1963 Corvette: Service Bulletin: Interim Production Changes

Subject: Interim Production Changes
Model and Year: 1963 Corvette
Source: Chevrolet Technical Service Bulletin
Bulletin No: DR #569
Section: XV
Date: December 31, 1962

PARKING BRAKE LEVER ASSEMBLY REPLACEMENT

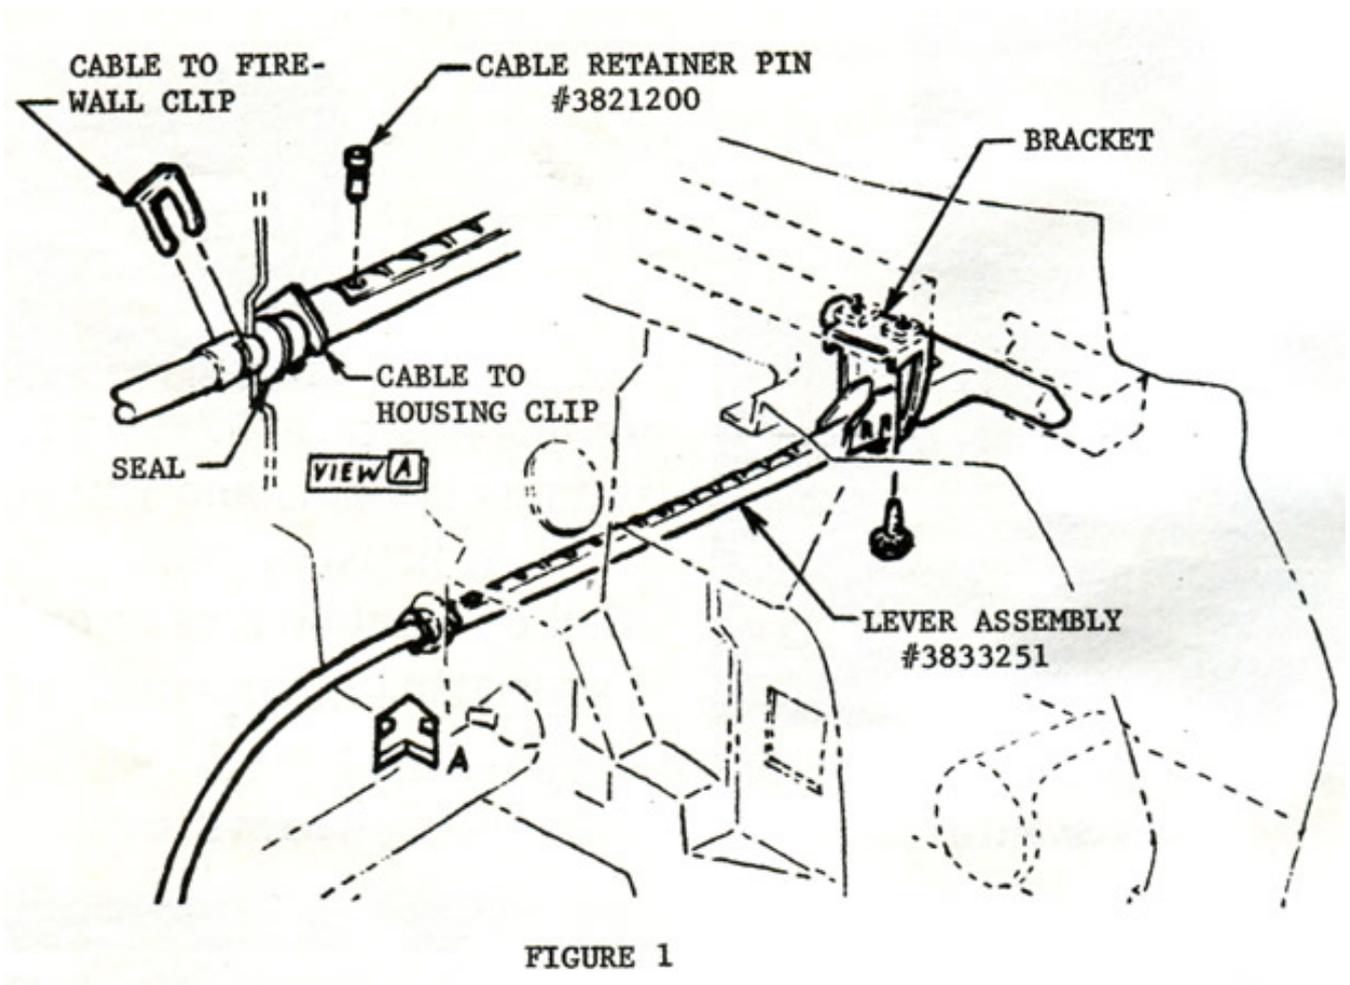
1. Effective with Serial No. S101893, a redesigned parking brake lever assembly entered Production. Early vehicles incorporate a lever assembly which may be difficult to release and in extreme cases, may actually jam making release impossible.
2. Vehicles with Serial No. S101847 through S102667, were built with a second design rear axle driveshaft flange that may not seat properly in the rear wheel drive spindle flange. An interference condition at this location could possibly lead to early failure of the rear wheel spindle flange attaching bolt bosses.

Lever Assembly should be replaced on all vehicles built prior to Serial No. S101893. Referring to Figure 1, proceed as follows:

1. Scrape sealer away from cable to firewall clip and remove clip.
2. Disconnect parking brake cable clip from steering gear retainer bolt.
3. Disconnect oil pressure line at gauge and pull line out of parking brake lever assembly bracket.
4. Remove two (2) bolts holding bracket to dash brace.
5. Pull complete lever and cable assembly to the rear, far enough to remove parking brake signal switch.
6. With handle all the way in, cable retainer pin will line up with hole in bottom of housing allowing pin to be driven out from bottom with a punch.
7. Remove cable to housing clip and separate cable from housing.
8. Install original seal on new lever assembly No. 3833251.
9. Reassemble by reversing the above steps using new cable retainer pin No. 3821200. NOTE: Chamfered side of pin must face forward to

actuate the parking brake signal switch properly.

10. Apply body sealer around cable at firewall to prevent water leaks.

FIGURE 4 - SPINDLE FLANGE

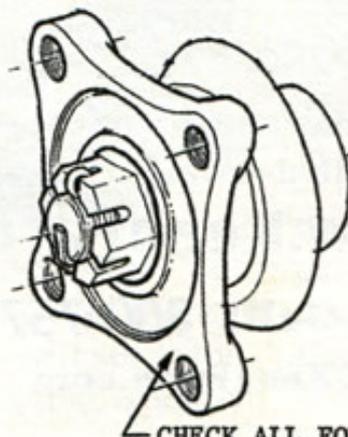
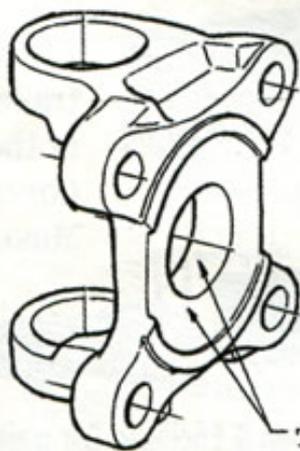
New machined Driveshaft Flanges No. 3832048, should be installed on all vehicles with Serial No. S101847 through S102667 (Ref. Figs. 2 and 3).

Replacement of the driveshaft flange is covered in the 1963 Corvette Shop Manual, Page 4-16. The rear wheel spindle flange attaching bolt bosses should be visually inspected while the axle driveshafts are out of the vehicle. Replace with new Spindle Flange Assembly No. 3830253 if any cracks are evident in the area indicated in Figure 4.

FIGURE 4

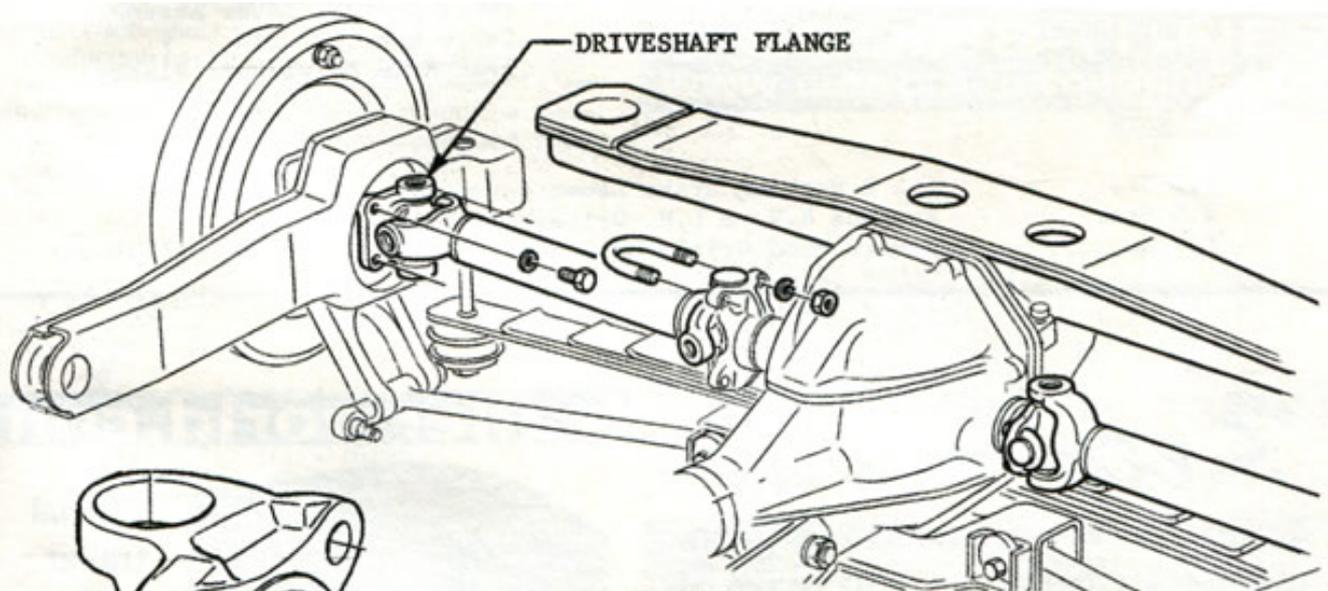
3. Vehicles prior to Serial No. S105362 may have interference between the radiator top tank inlet and one of the simulated hood grille attaching studs. Contact at this point might eventually rub through the radiator inlet causing loss of water and cooling system pressure.

All vehicles built prior to Serial Number S105362, may have interference between the hood simulated grille attaching stud indicated in Figure 4, and the radiator inlet. To eliminate possible radiator damage, the following steps should be followed:

Current production radiators incorporate a small depression in the inlet to insure adequate stud to radiator clearance.

1. File or grind stud off flush with lower face of nut.
2. Inspect radiator inlet for any signs of leakage in the area of stud contact.
3. Place a small thin piece of body sealer or clay on radiator inlet and close hood. Open hood and inspect sealer or clay to determine if metal to metal contact still exists. If necessary, carefully tap a small depression in radiator inlet using a ball peen hammer and recheck clearance with sealer or clay.
